Access Compliance Report

Public Rights-of-Way

| Intersection ID: 9610 | Main Street: BARRINGTON_DR | Cross Street: THE_PLAZA | Location: | N |
| ADA ID: 56E8287B4739 | Ramp Type: PerpDiag | Initial Pass/Fail: Fail | Overall Compliance: No | Severity Score: 12.5 |

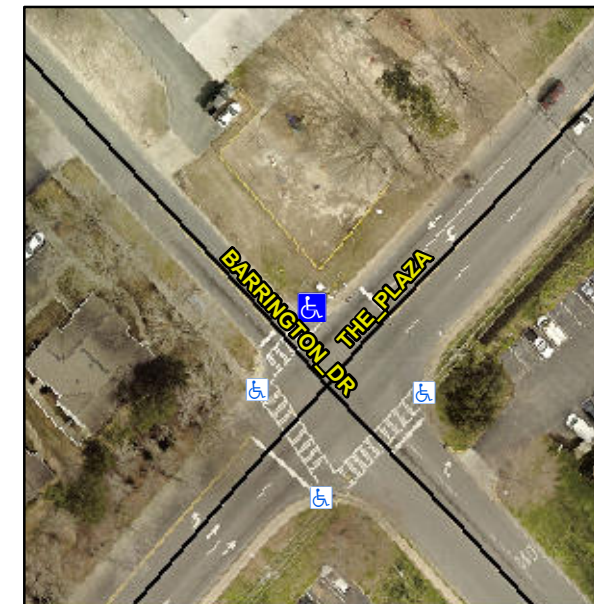
Not Found, R304.2.2

| Compliance | Description | Data | Compliance | Description | Data |
|------------|-----------------------|-------|------------|-----------------------------|-------|
| N/A | Ramp Length (in) | 56.0 | No | Ramp Slope (%) | 11.0 |

Remove & Replace Curb Ramp With Two New Directional Ramps or Equivalent.
